RE: Smalls Road Public School - ACCESSIBILITY ISSUES AT DD STAGE - FINAL

Please find accessibility issues report with regards to the new Public School located at Smalls Road Ryde NSW 2112.

PROJECT
DoEAMD-16-14 Smalls Road,
Ryde Public School

DRAWING
Staff Block - Ground Floor -
Sheet 1

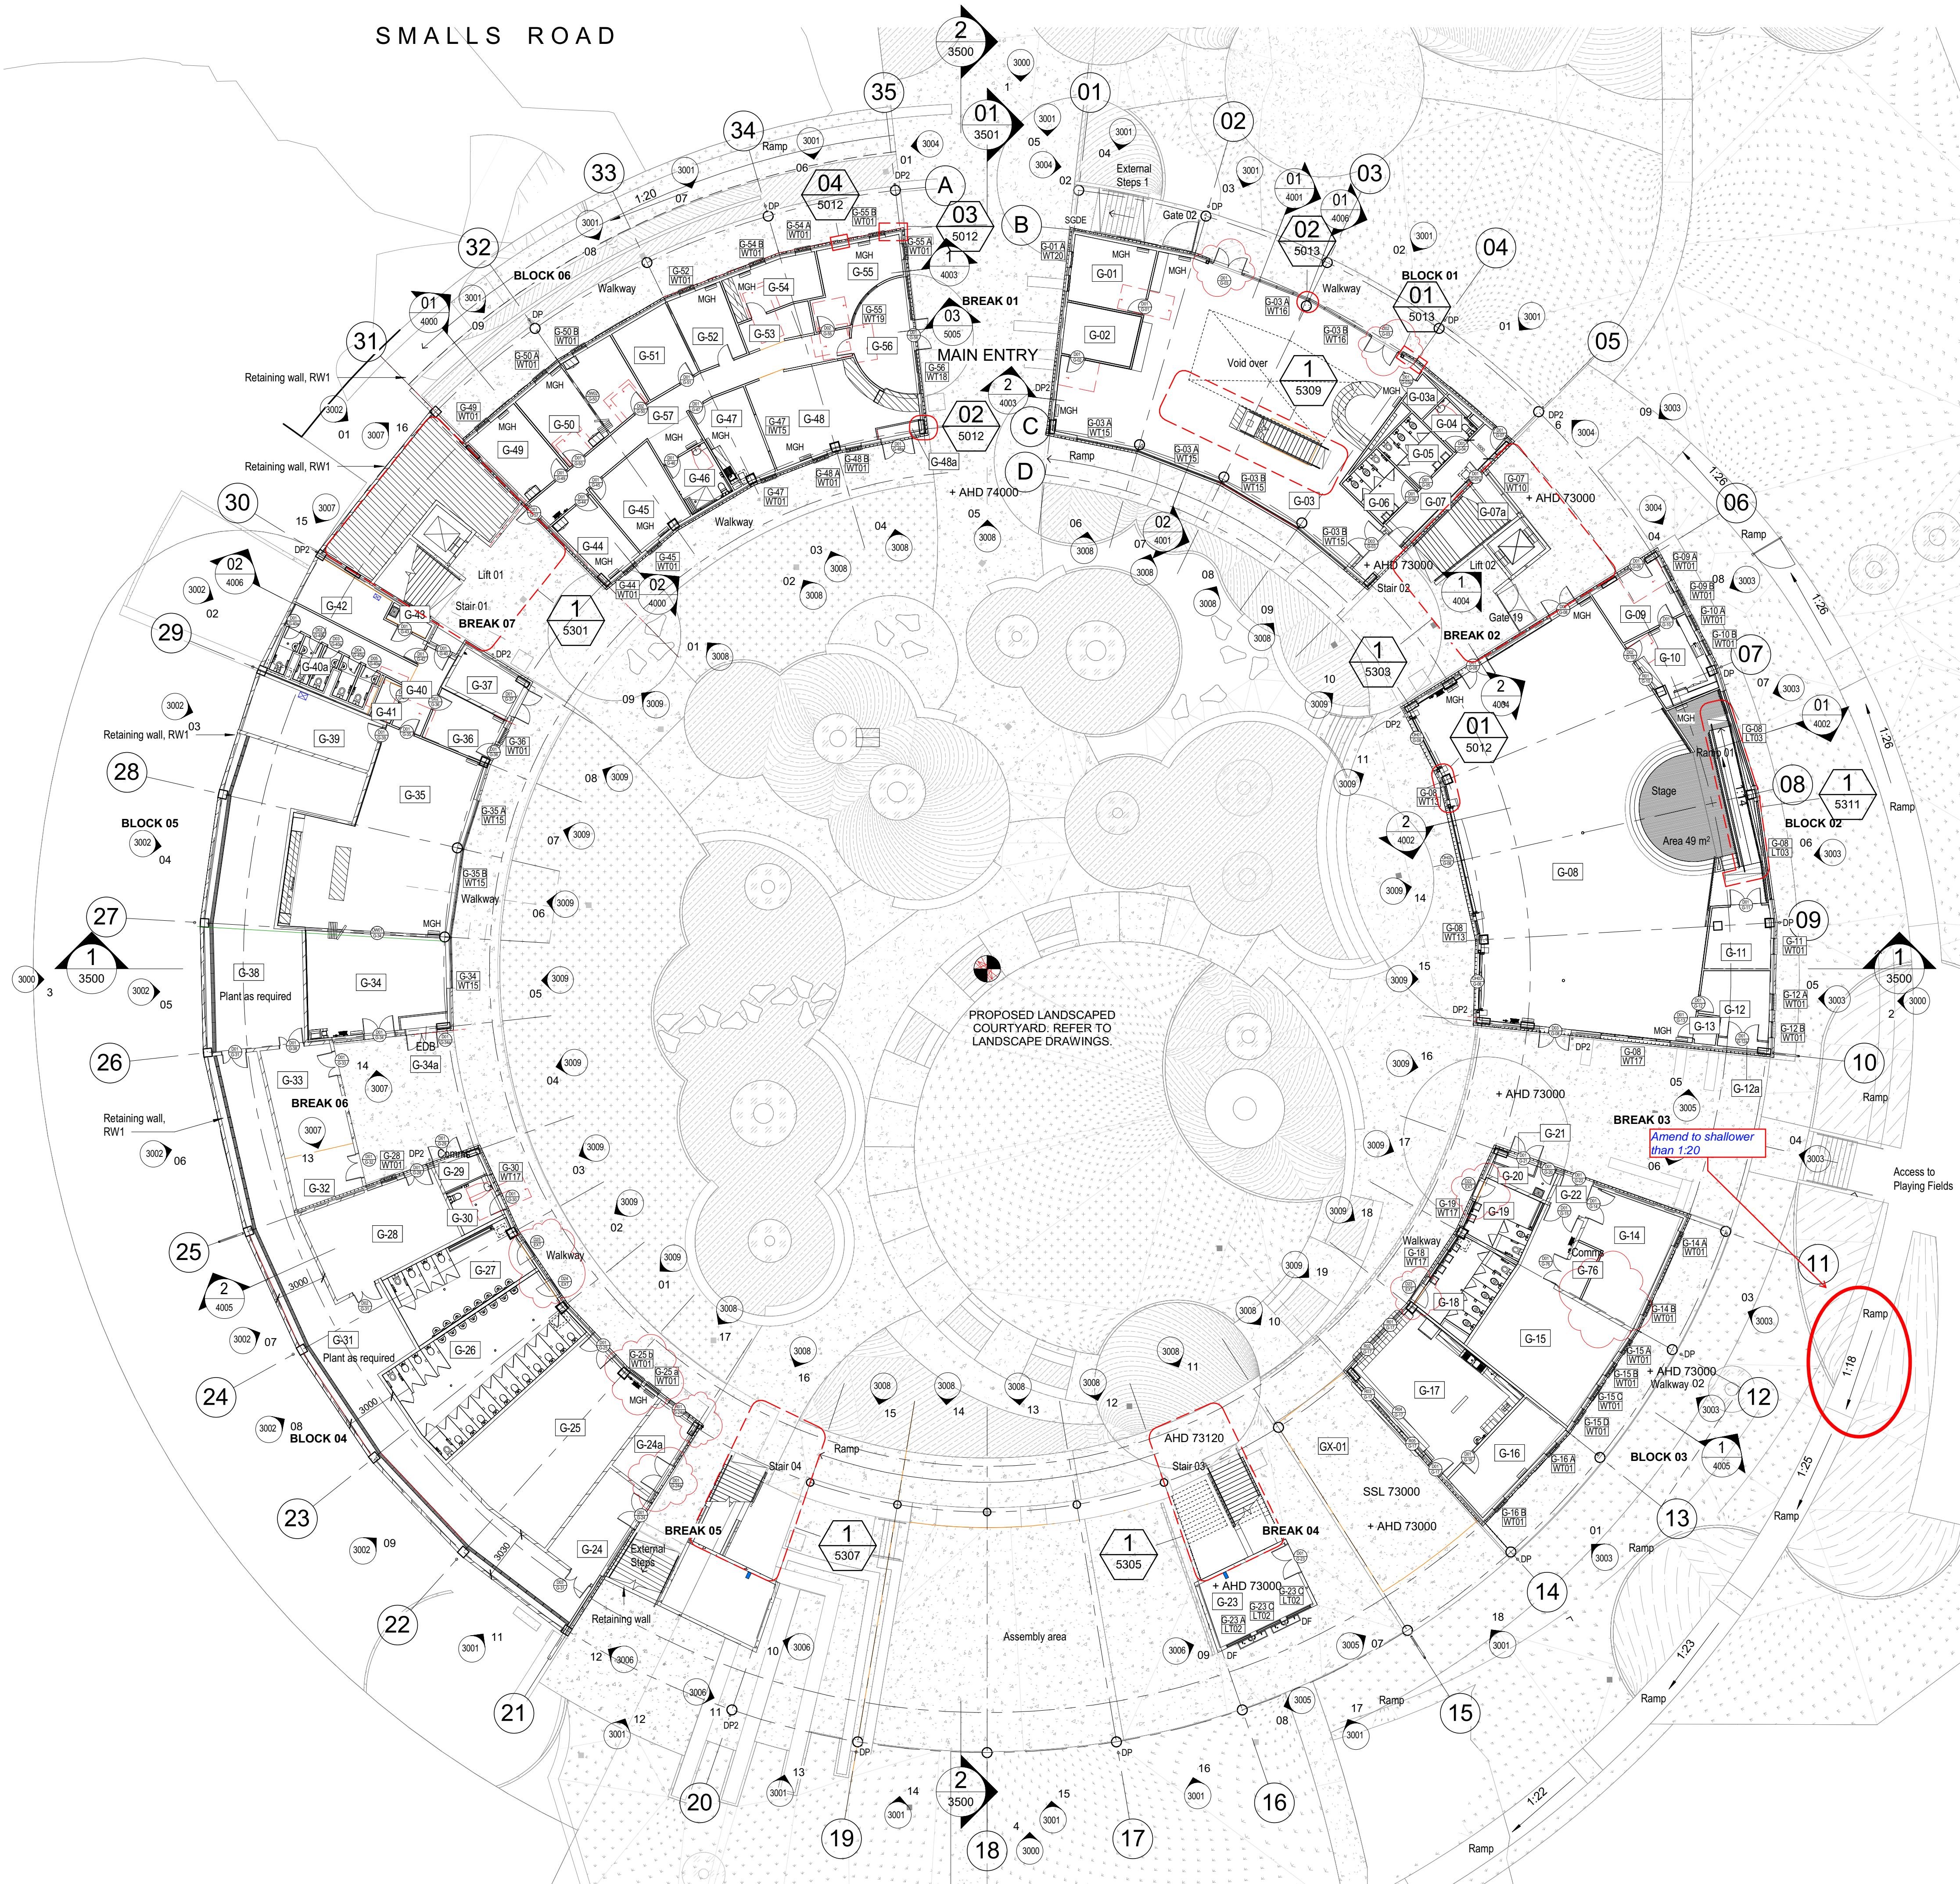
3.5.		NEW ISSUE Corridor at Staff Block amenities is too narrow for wheelchair turning. Can be supported under a Performance Solution .
4.0	Doors This section relates to all common-use doors and/or doors required to be accessible.
